2 Type of change

Improved electrical contact

Product Change Notification						FEU fingergrip improvement		
owner	creation date	release date	released by	change order no	rev	page	D40 046 044	
dislercy	08.06.2017	21.12.2017	haeckima	2013038	Α	1 of 1	D10-016-241

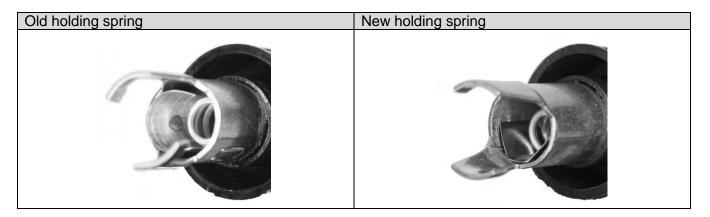
The contact spring on FEU finger grip carrier and FEU (Grip) carrier for 6.3x32mm fuse is improved.

Form	Yes	Contact spring of fuse carrier changed
Fit	No	No change for dimension
Function	No	No functional change
Production Site	No	No change of the production site
Product Label	No	No label on the change
Packaging	No	No change in packaging
